LiDAR Quality Assessment Report

MN_MNRRiverBasin-Phase1_2010

Kandiyohi County is one of the 25 counties as part of the Minnesota River Basin - Phase 1 lidar project.

MN_KandiyohiCo_2010

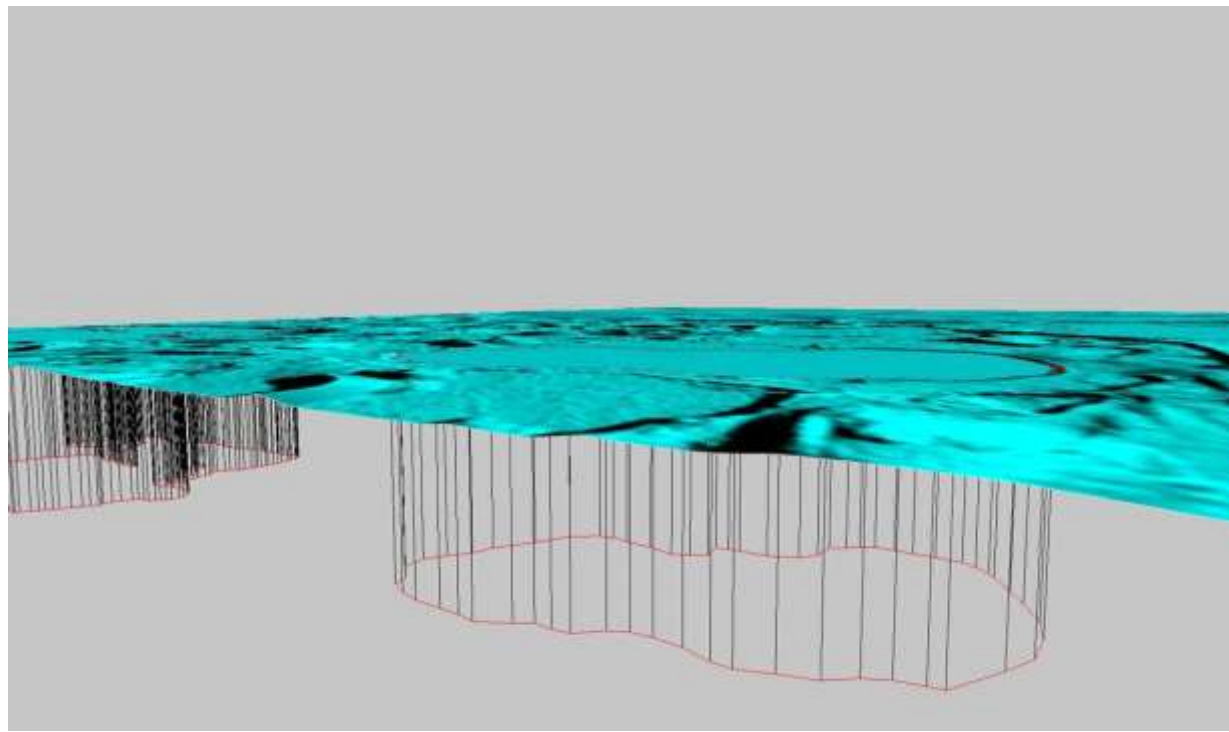
Breaklines are Polygon ZM, however there is no elevation information associated with them. Water bodies are flattened.

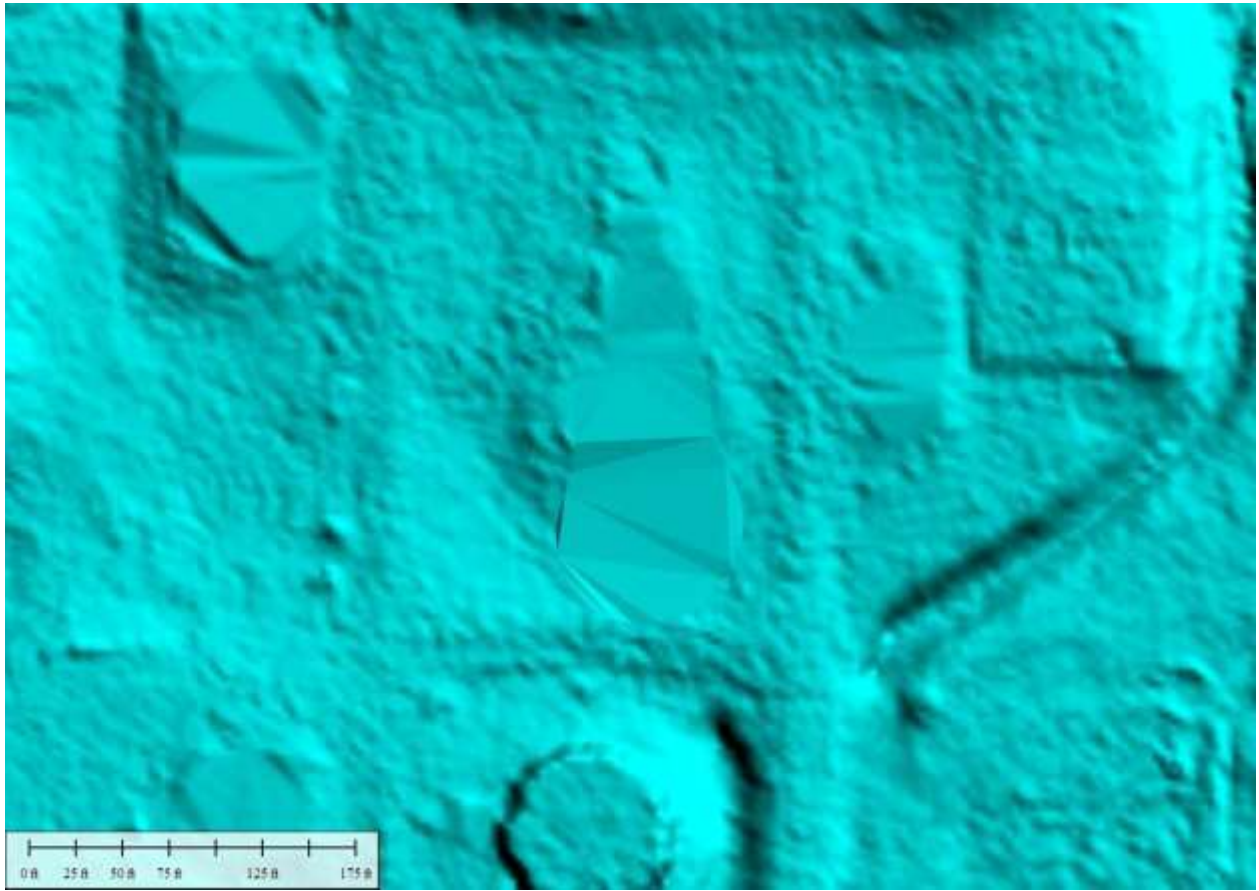
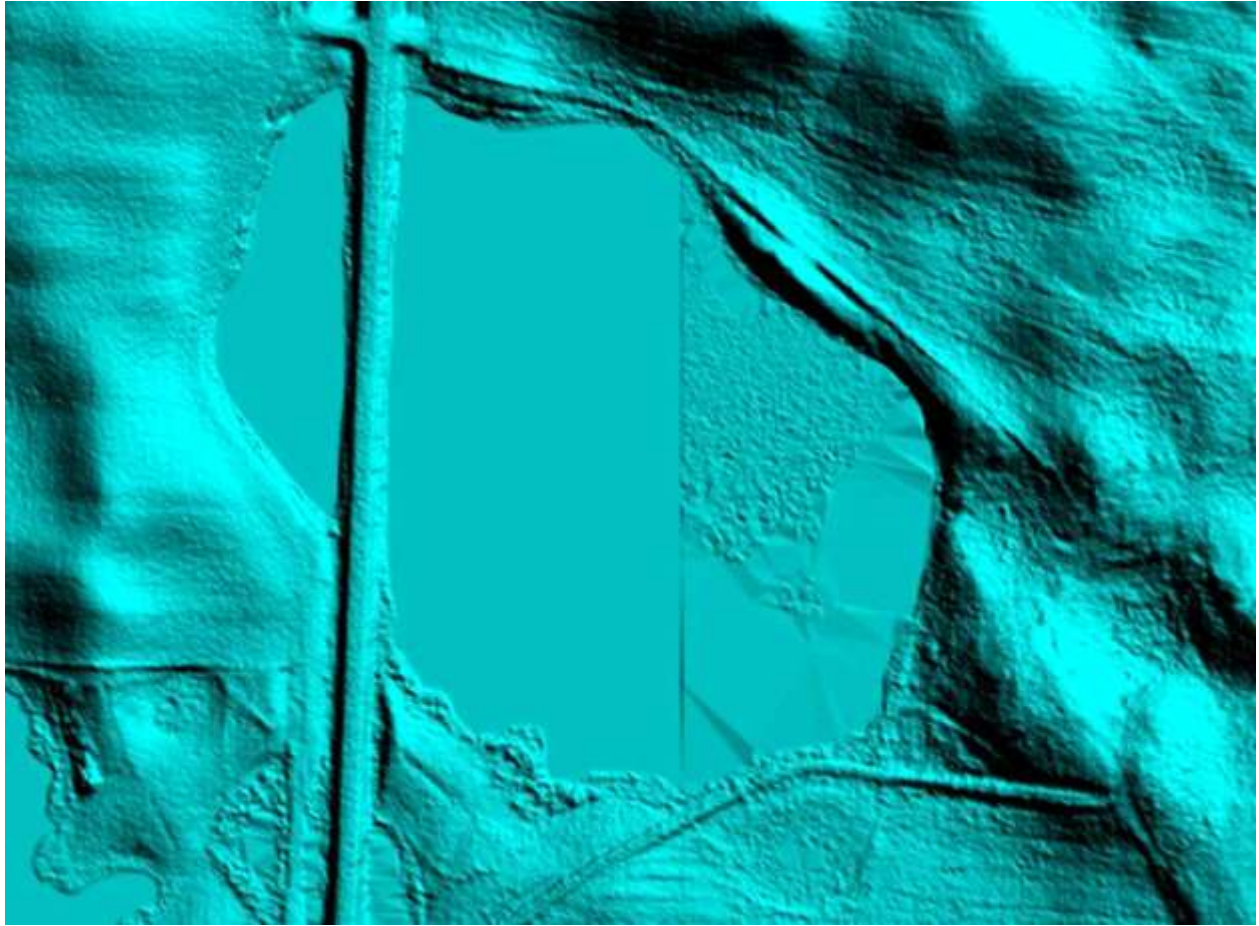
building and pit: Remnants of a structure and an associated pit were altered in the DEM by the addition of a 'patch' covering them. See image below for results. Work performed by NGTOC personnel.

building and pit: Error remedied.

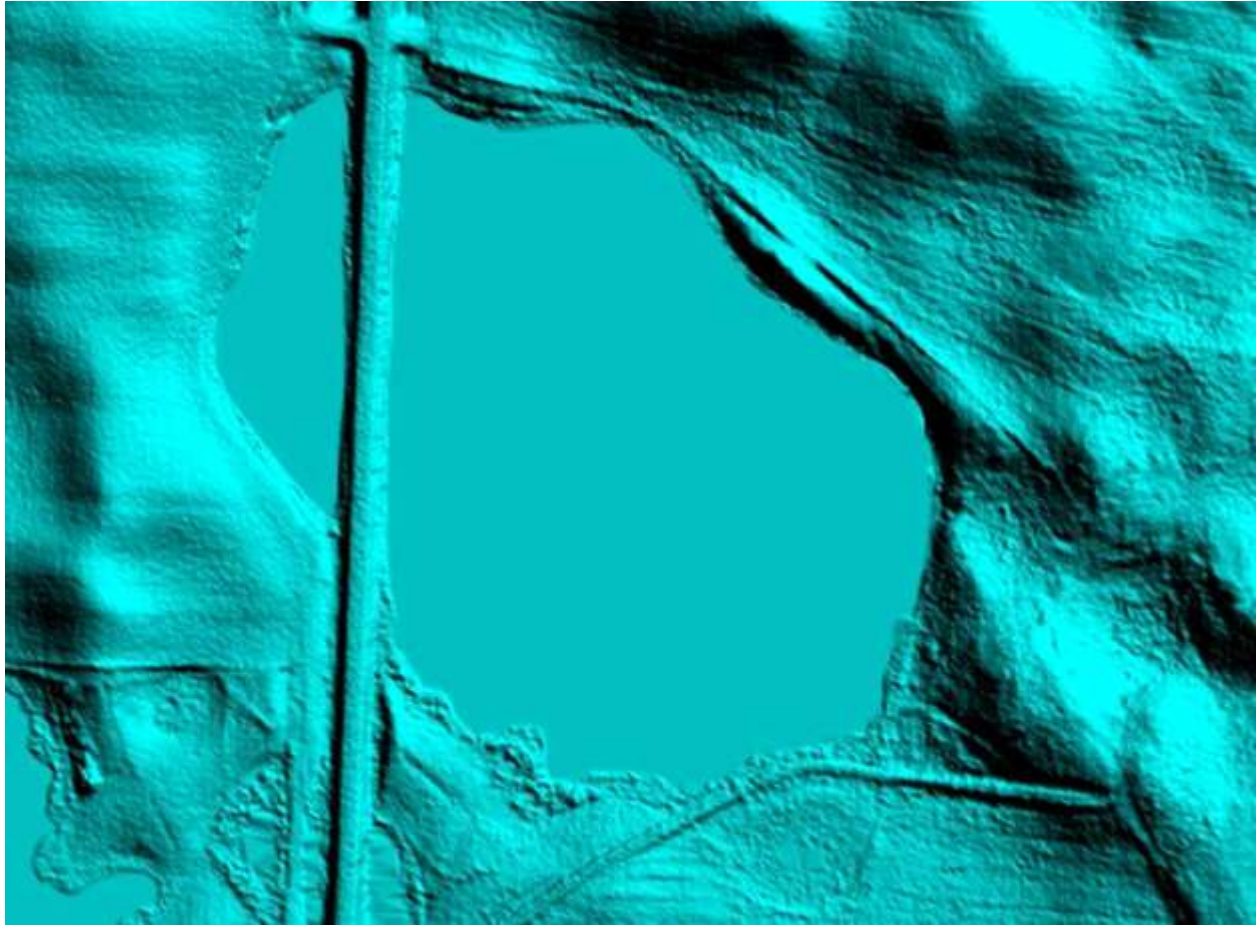
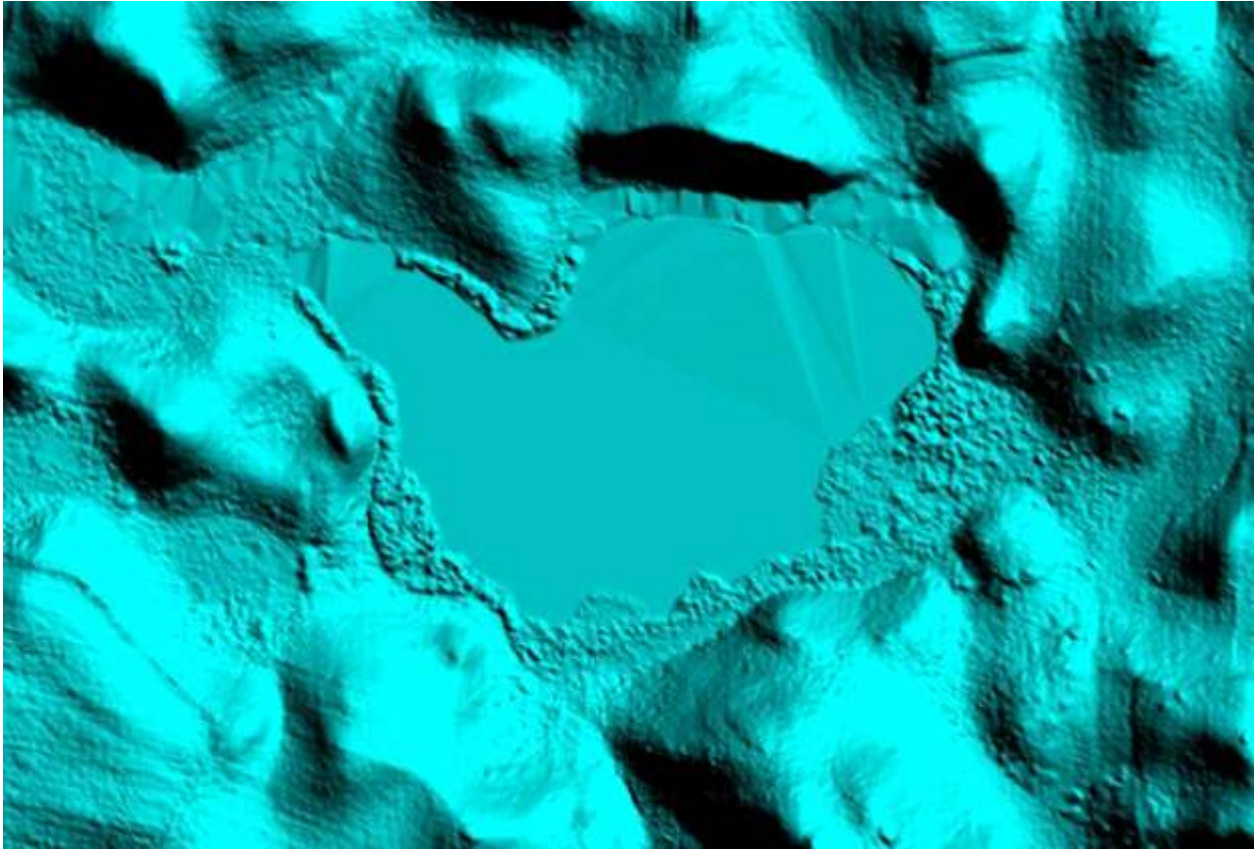
TIN_1: Portion of water body is TIN'd; this error was 'fixed', in the DEM only, by NGTOC personnel. See image below for results.

TIN_1b:

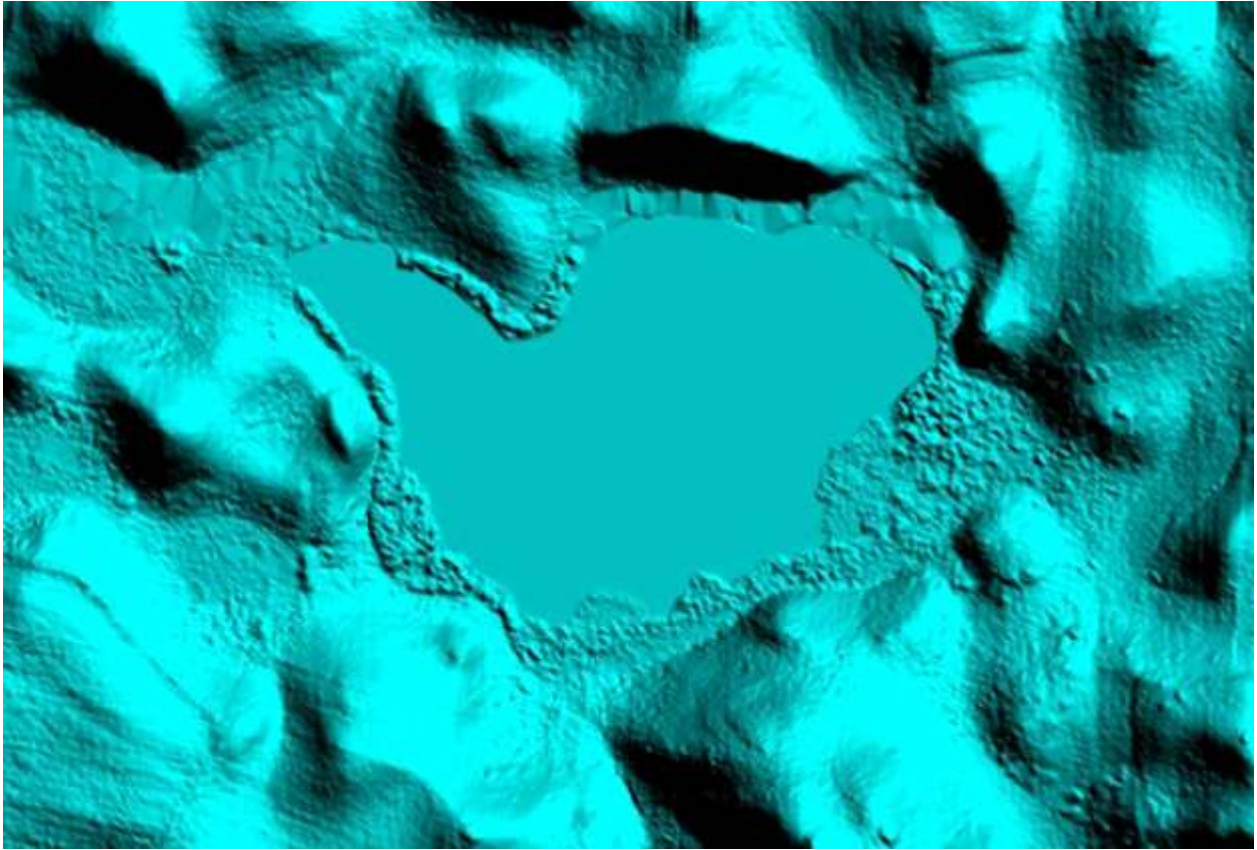
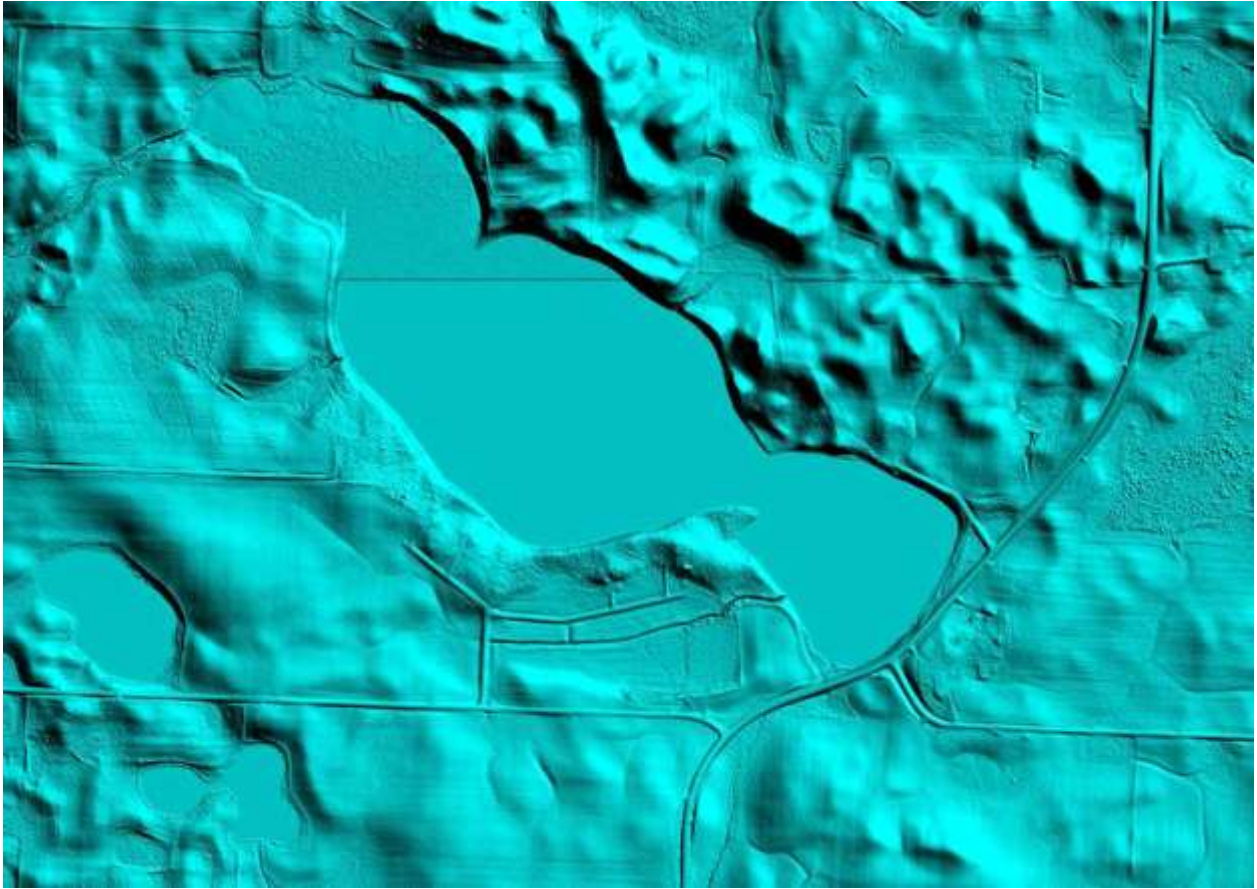
TIN_2: Two portions of this water body are TIN'd (upper left, upper right). These errors were 'fixed', in the DEM only, by NGTOC personnel. See image below for results.

TIN_2b:

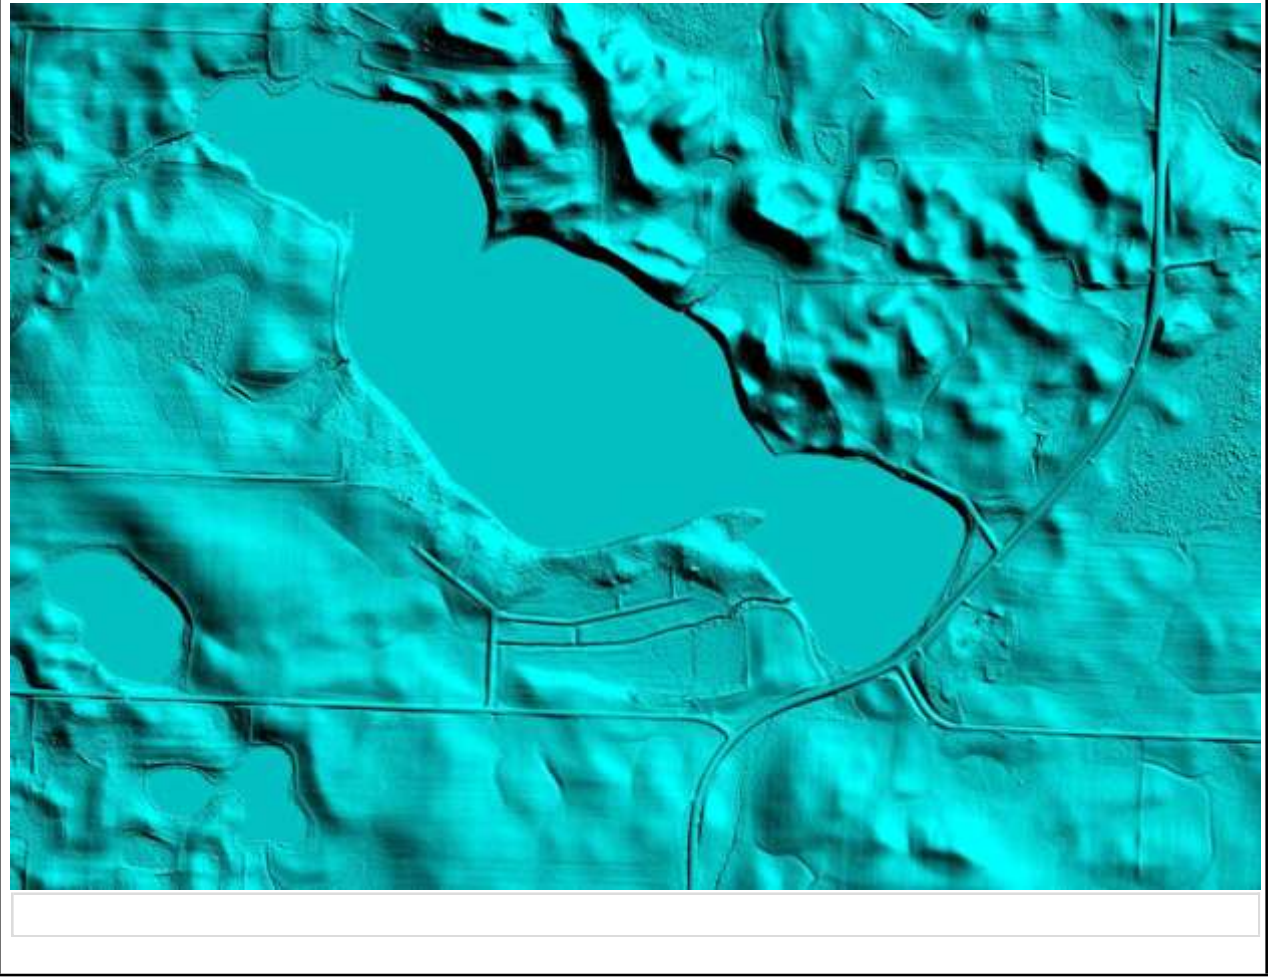
TIN_3_seam: Upper portion of this lake is TIN'd and a seam is very apparent. This error was 'fixed', in the DEM only, by NGTOC personnel. See image below for results.
